FRAMFIELD PARISH COUNCIL

Minutes of a Planning Committee Meeting held on Monday, 16 January 2023, at 6 pm in the Village Hall, Blackboys.

WD/2022/2785/MAO – Outline application for the erection of up to 210 dwellings with public open space, landscaping and sustainable drainage system (SUDS), vehicular access point and provision for suitable alternative natural green space (SANG). All matters reserved except for means of access.

Land north of Eastbourne Road, Uckfield.

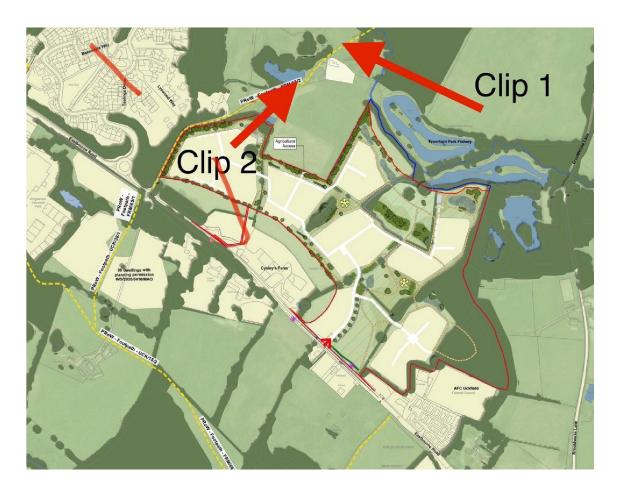
Five residents spoke strongly against the application. At the end of these comments there is also a diagrammatic and link with videos to flooding issues on the site sent into the Parish Council by a resident.

Clip 2 is water draining from the proposed site directly off the field that is adjacent to the footpath and Eastbourne Rd. It then washes over the track/footpath into the lower pond and floods over the top into the fields below. If an expert could calculate the volume/flow from these clips it would clearly show a few SUD ponds would be over whelmed quite quickly.
